P&ID
COMPRESSED AIR
UNIT 2
(INSTRUMENT AIR COMPRESSOR 2A)

LIMERICK GENERATING STATION
EXELON NUCLEAR CORP.

SHEET 18 OF 8031-M-15 14

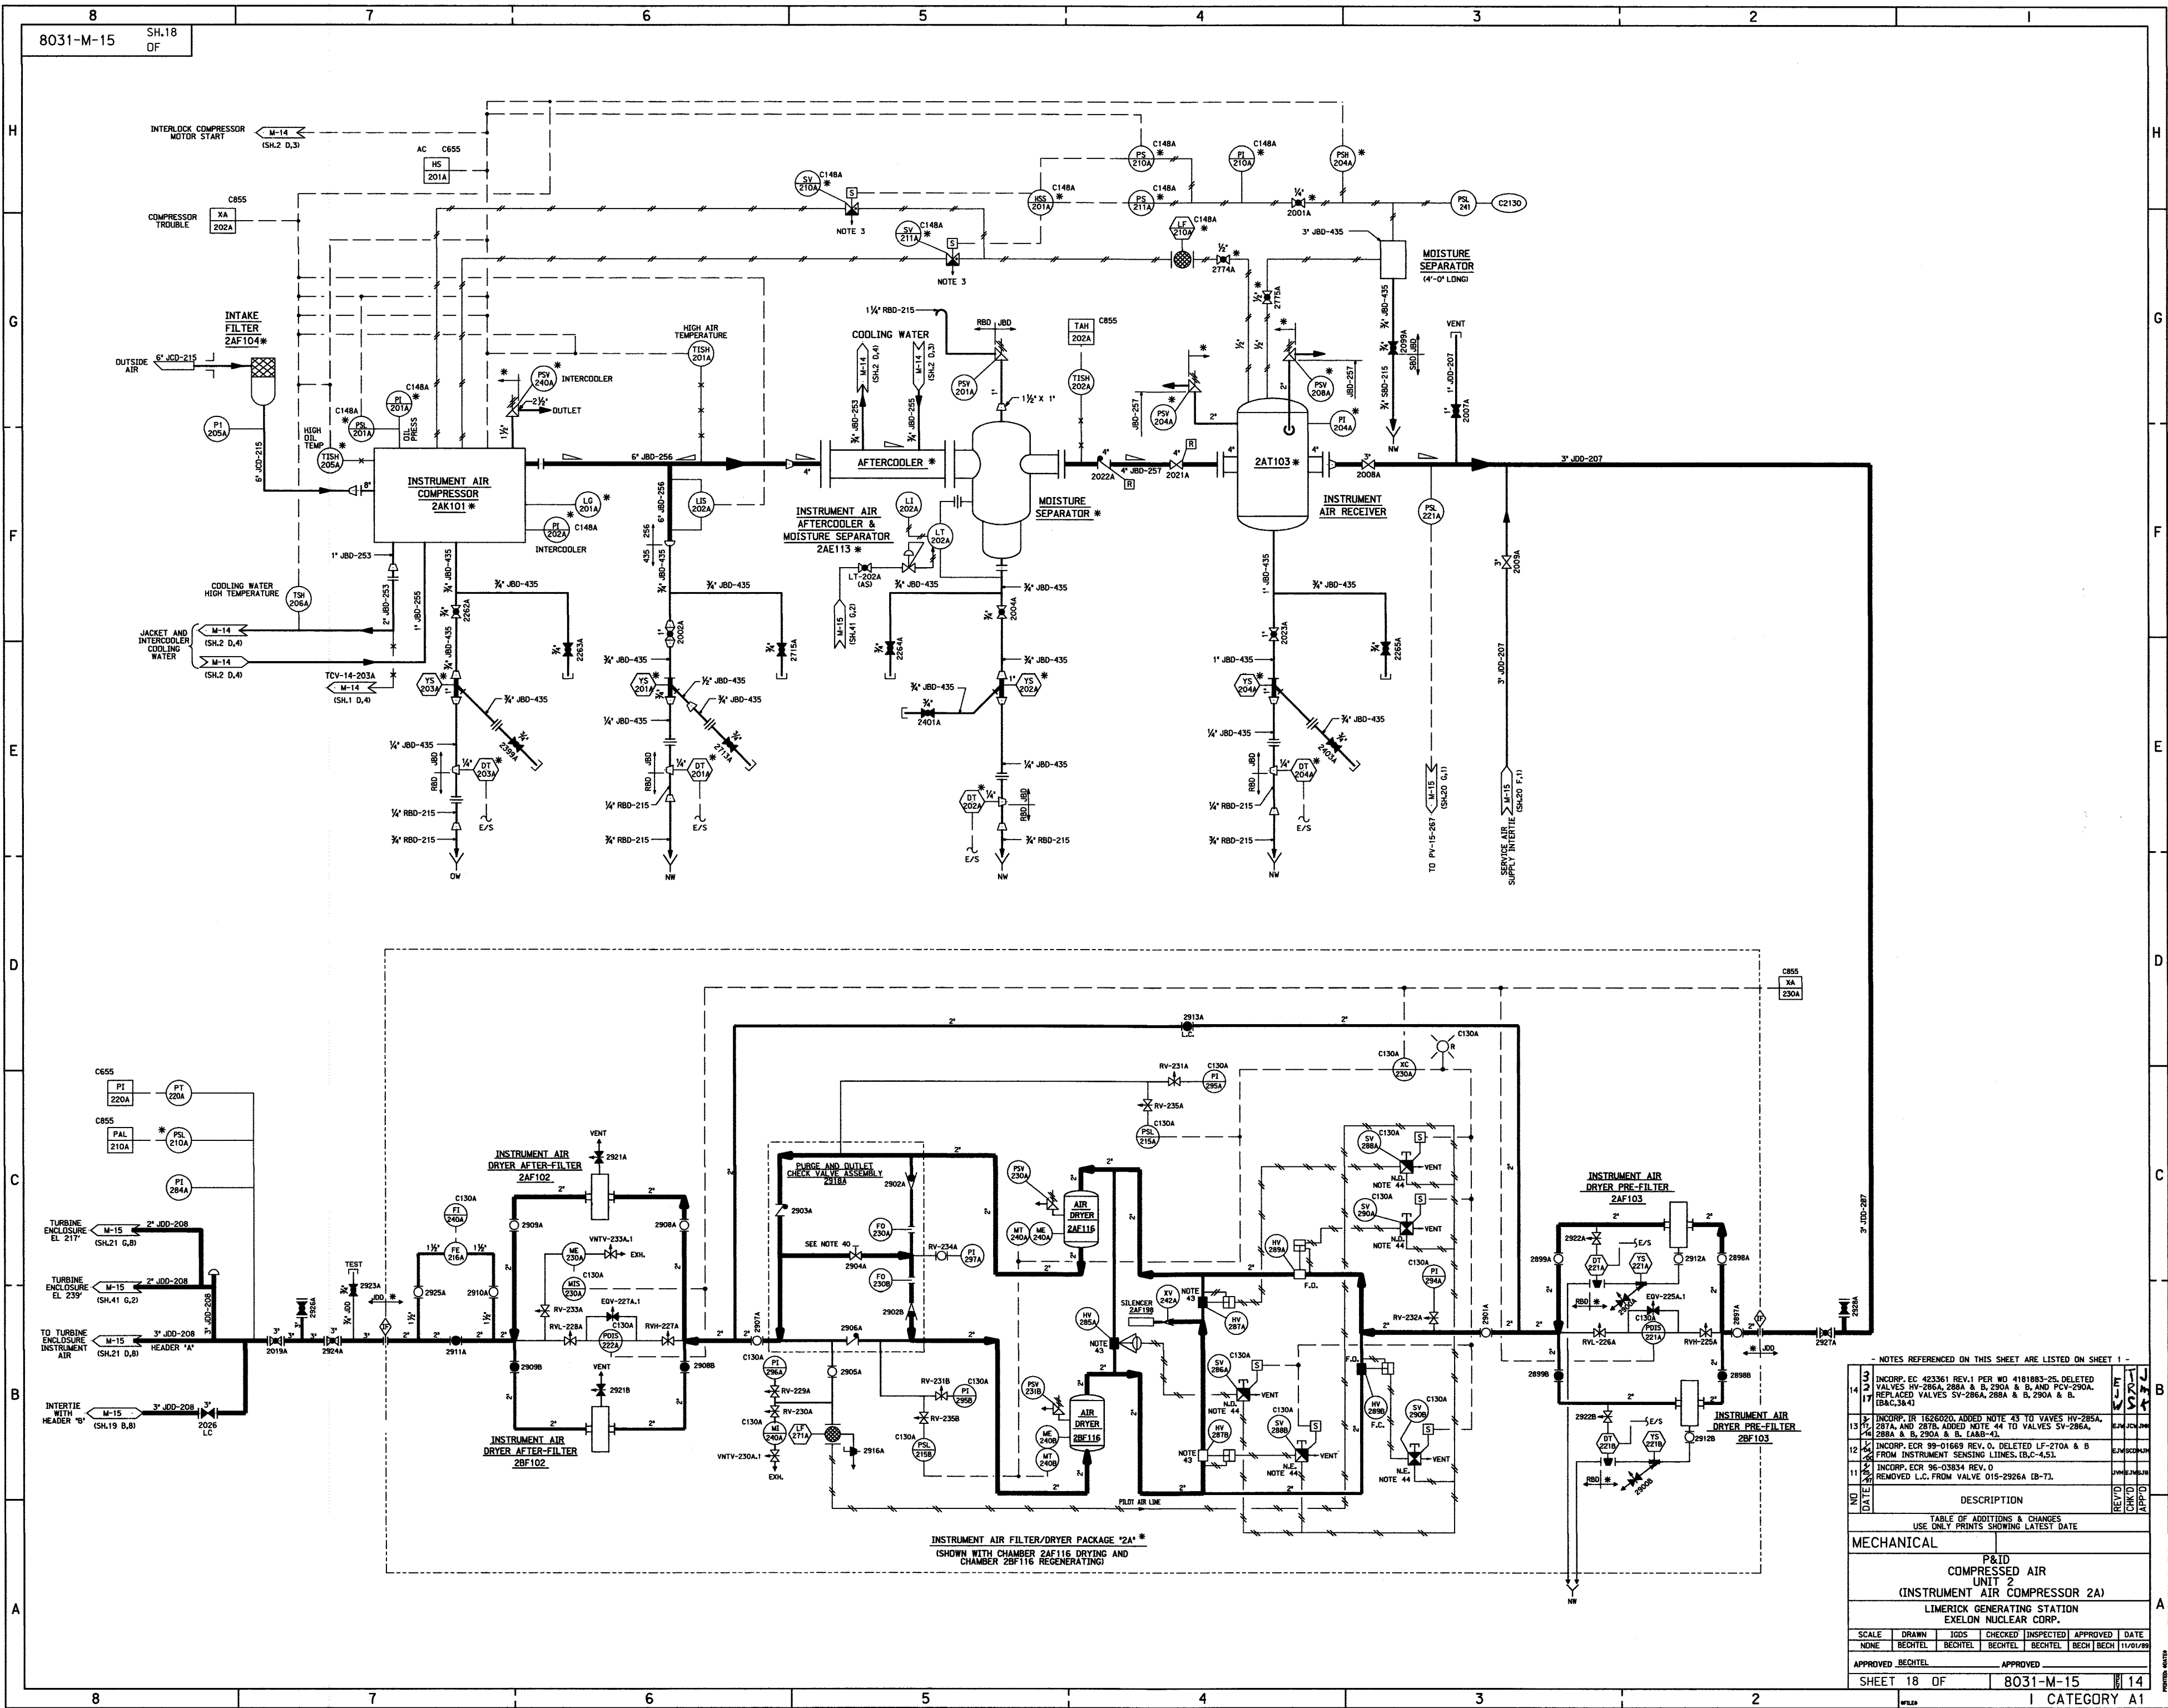
14	INCORP. EC 42361 REV.1 PER WD 4181883-25, DELETED VALVES HV-286A, 288A & B, 290A & B, AND PCV-290A.	REV'D
17	REPLACED VALVES SV-286A, 288A & B, 290A & B.	REV'D
13	INCORP. IN 1626020, ADDED NOTE 43 TO VALVES HV-285A, 287A, AND 287S, ADDED NOTE 44 TO VALVES SV-286A, 288A & B, 290A & B, (A&B-43).	REV'D
12	INCORP. ECR 99-01669 REV. 0, DELETED LF-270A & B FROM INSTRUMENT SENSING LINES, (B.C-4.5).	REV'D
11	INCORP. ECR 96-03834 REV. 0	REV'D
10	REMOVED L.C. FROM VALVE 015-2926A (B-7).	REV'D
